NUREG-0565

Generic Evaluation of Small Break Loss-of-Coolant Accident Behavior in Babcock & Wilcox Designed 177-FA Operating Plants

Office of
Nuclear Reactor Regulation

U.S. Nuclear Regulatory
Commission

FIGURE 4-6

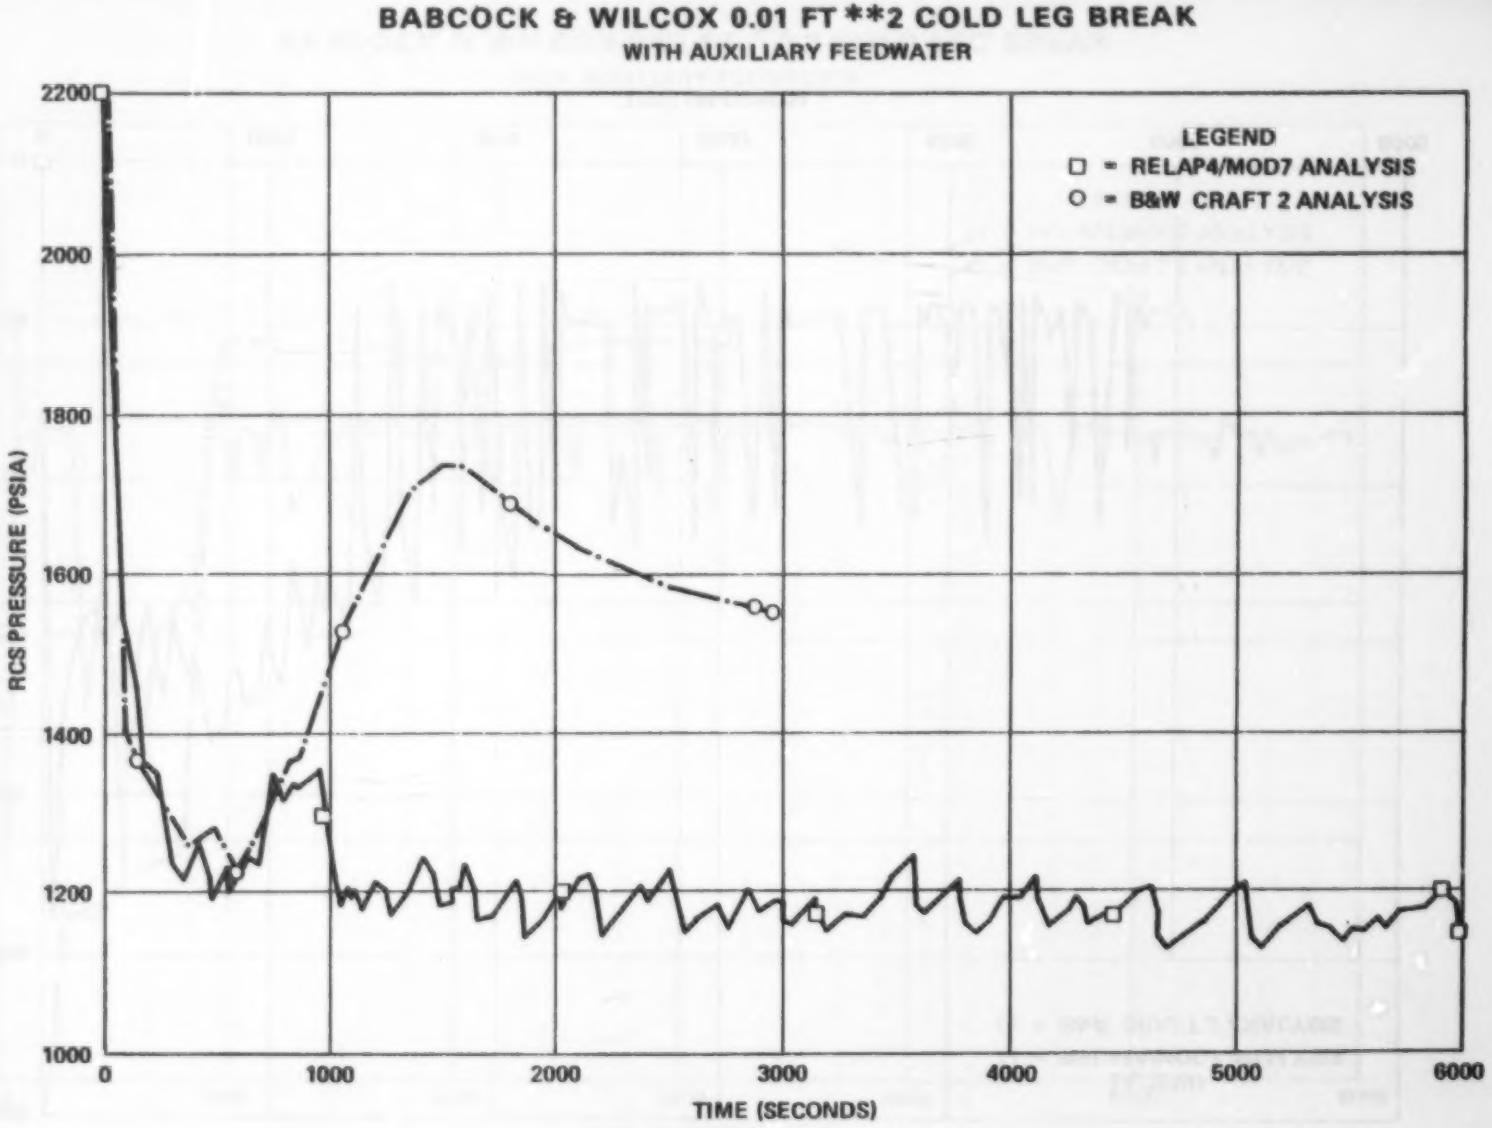
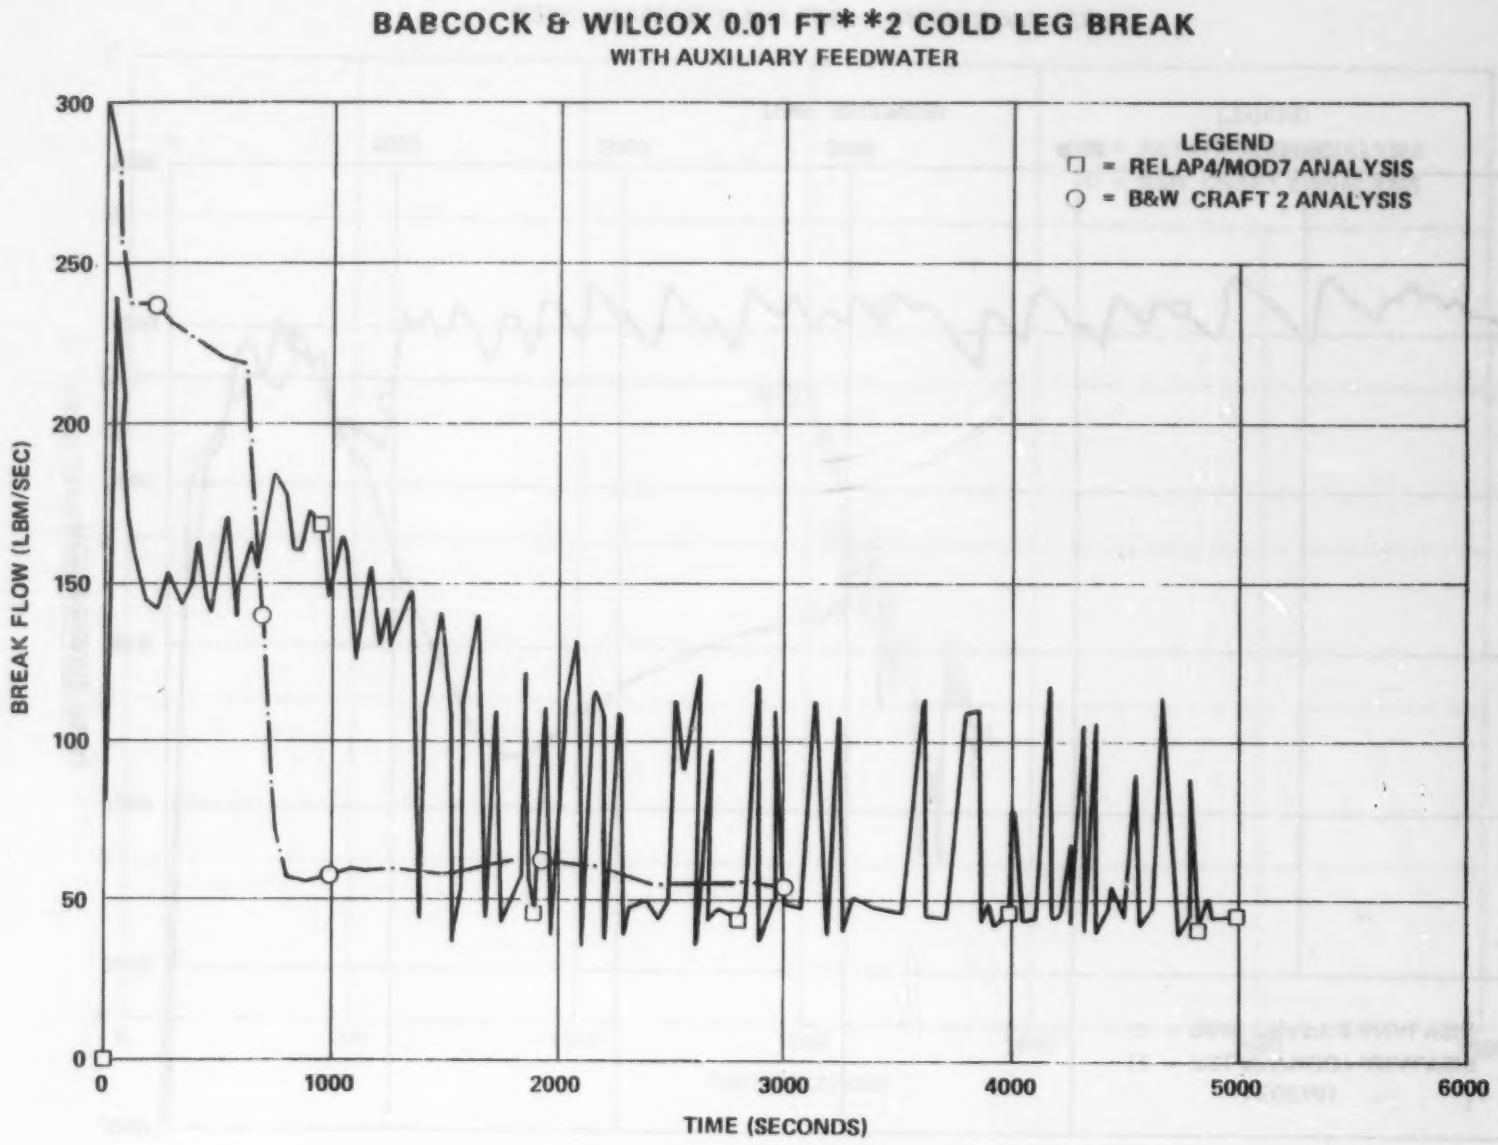
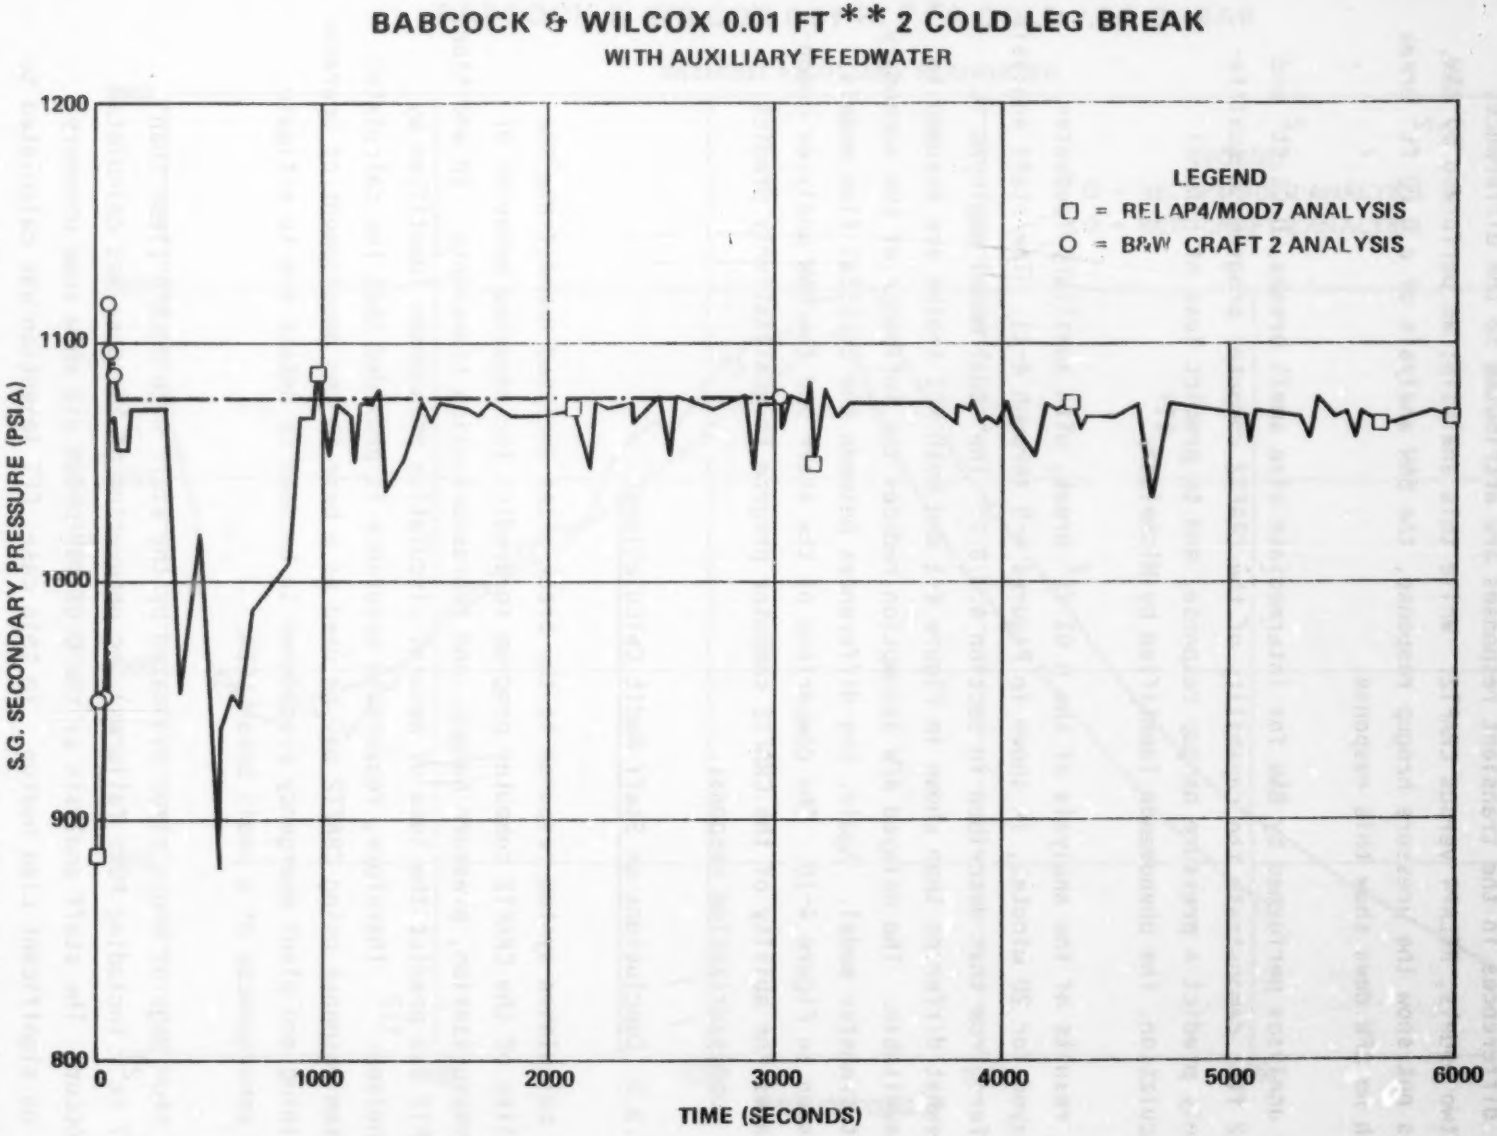
The analysis of the 0.01 ft^2 break with AFW is shown in Figures 4-6 and 4-8. The reactor coolant system pressure response is shown in Figure 4-6. The break flow is shown in Figure 4-7, and the secondary side pressure response is shown in Figure 4-8.

The influence of the critical flow model and the OTSG model is seen in Figures 4-7 and 4-8. The interesting comparison is found in the reactor coolant system pressure response, Figure 4-6. In the B&W analyis, the loss of natural circulation is quite pronounced, resulting in the repressurization to 1750 psia at about 1500 seconds. In the staff analysis, natural circulation is lost for a much shorter period, and the pressure tends to hang up while the steam generator pressure is near the safety valve setpoint.

FIGURE 4-9

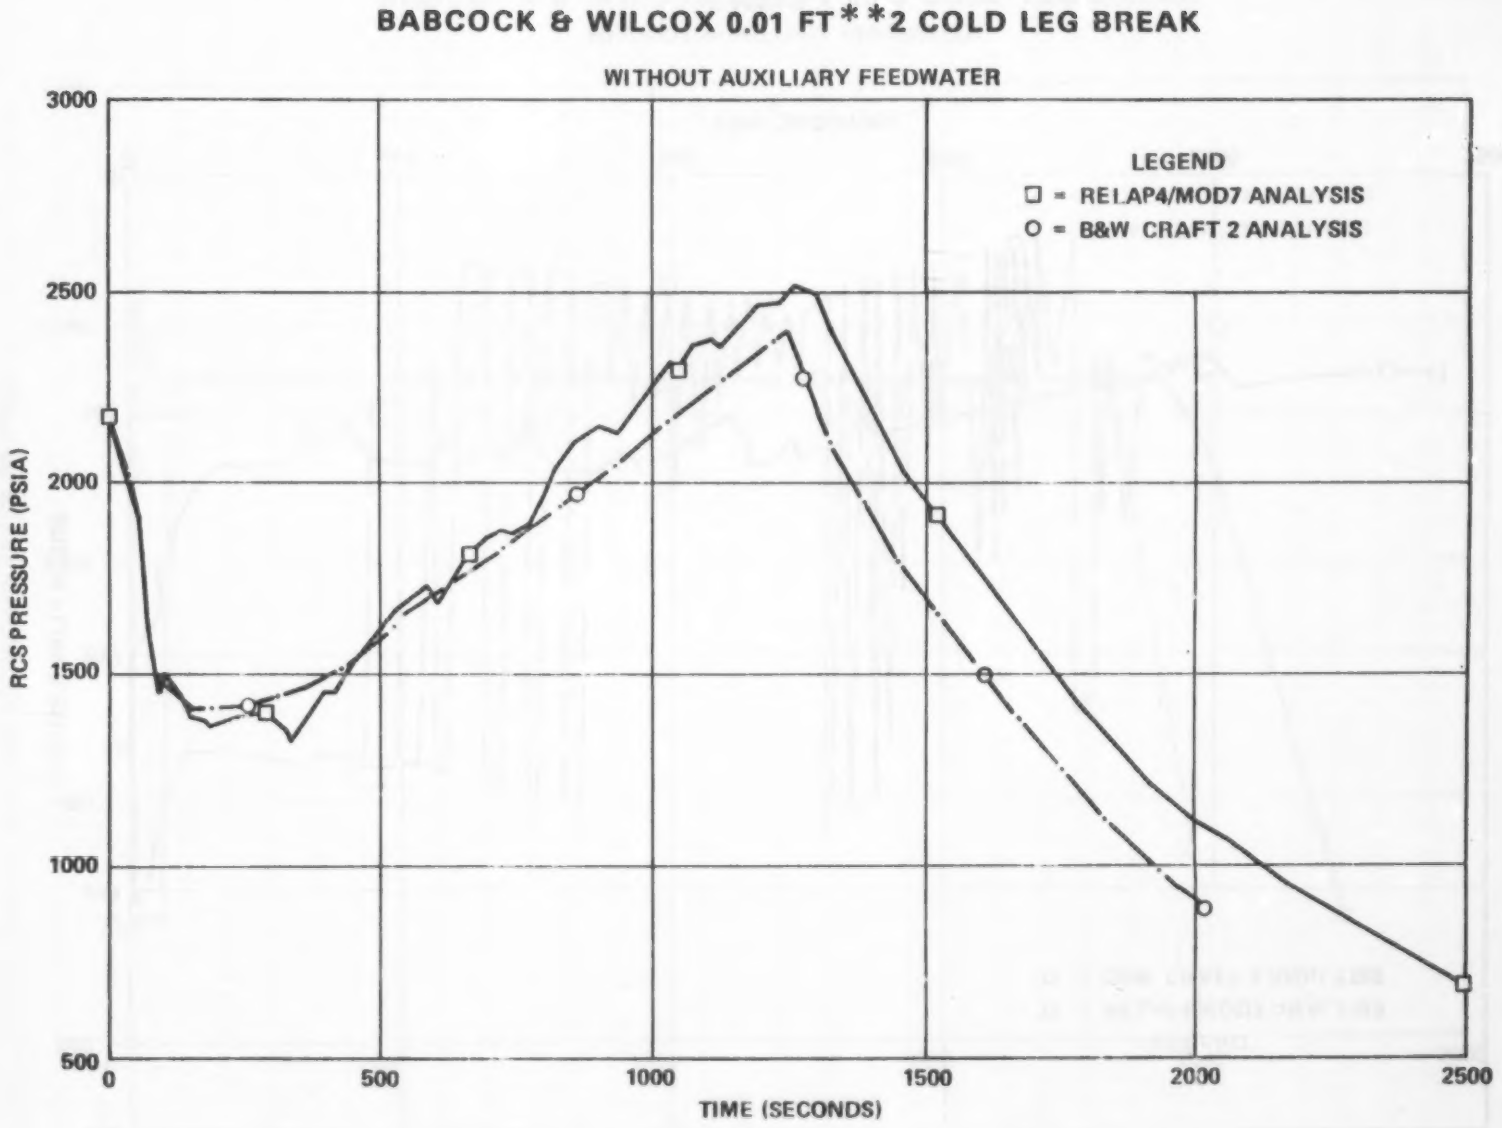
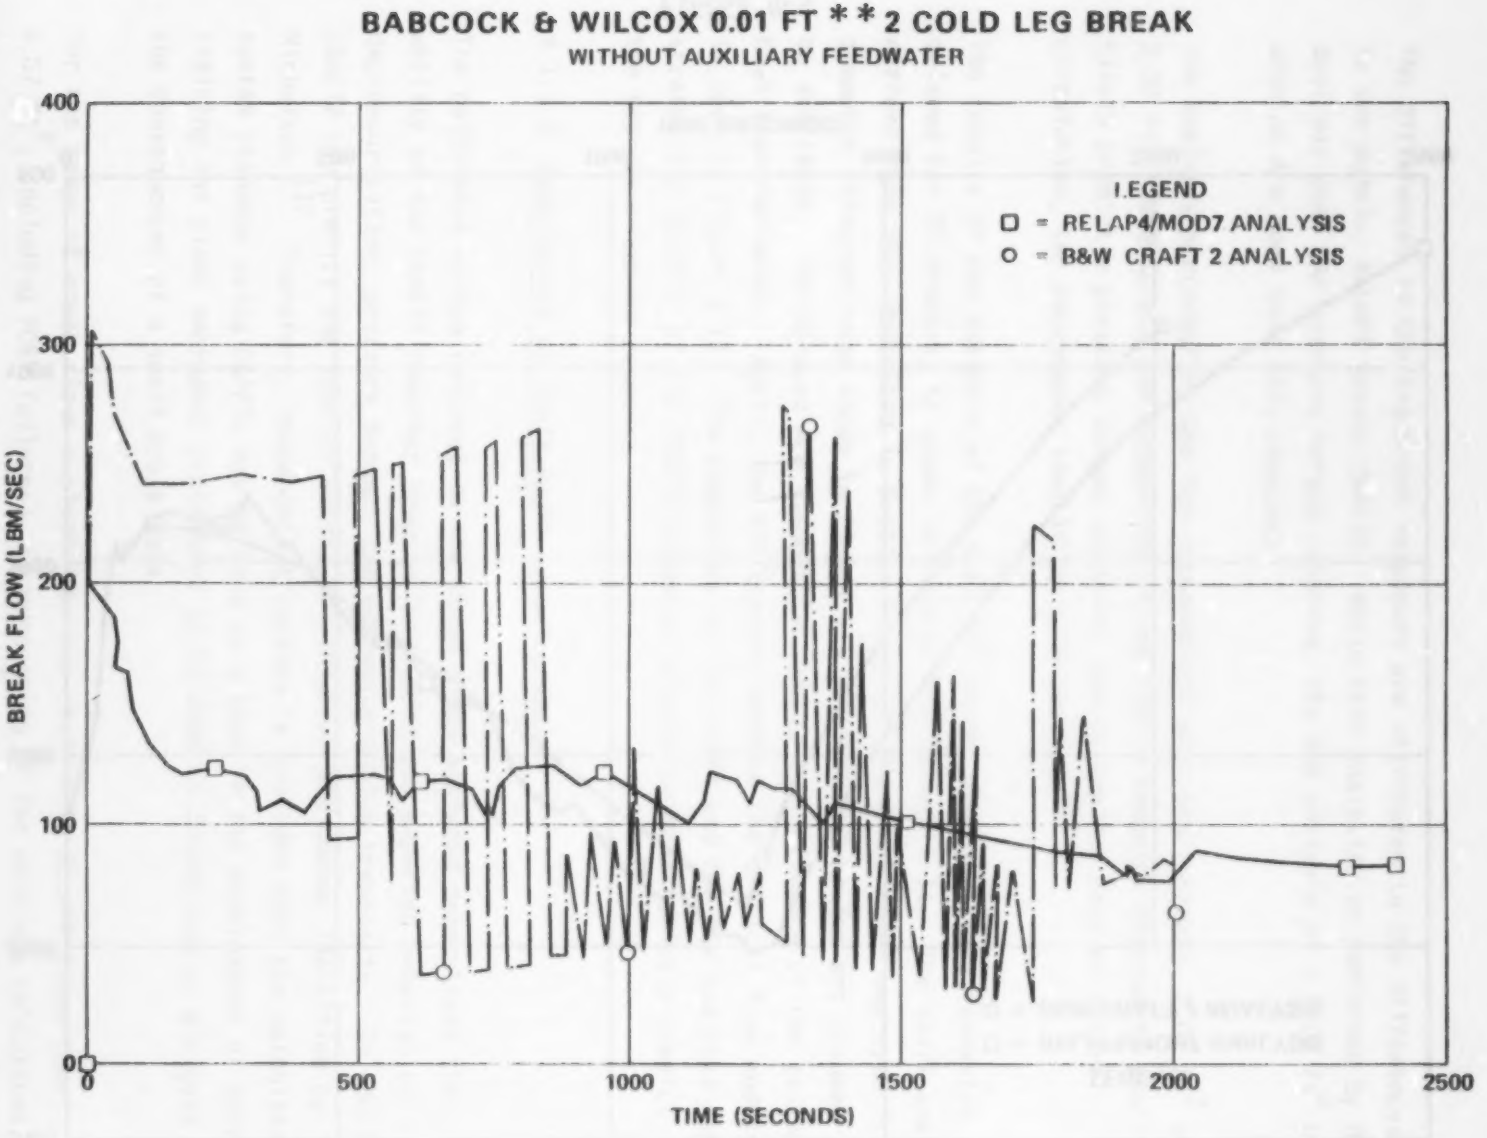
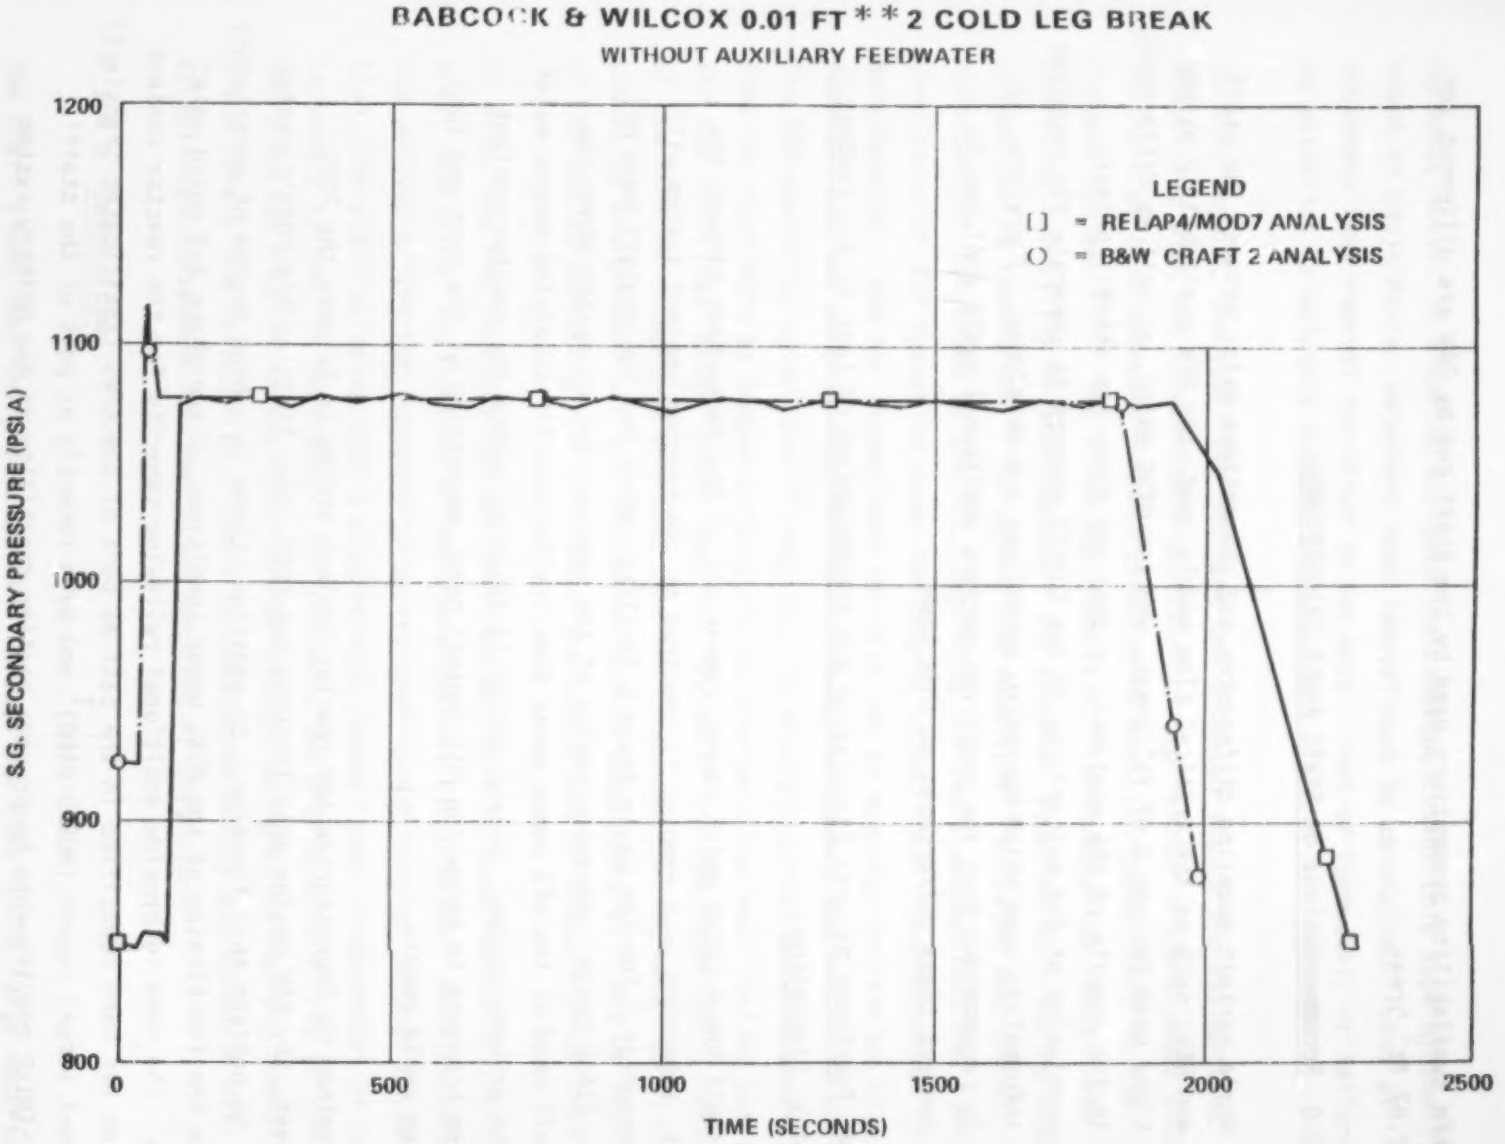
The results of the analysis of the 0.01 ft^2 break, with auxiliary feedwater delayed for 20 minutes, is shown in Figures 4-9 through 4-11. The staff analysis differs from that described in Section 4.1.3.2. The nodal model employed is somewhat different than shown in Figure 4-1 and both HPI trains are assumed to be available. The delayed AFW assumption reduces the influence of the secondary heat transfer model. Again, the differences between the critical flow models is seen in Figure 4-10. The comparison of the staff and the B&W analyses demonstrates the ability of the CRAFT2 computer program to qualitatively predict the repressurization response.
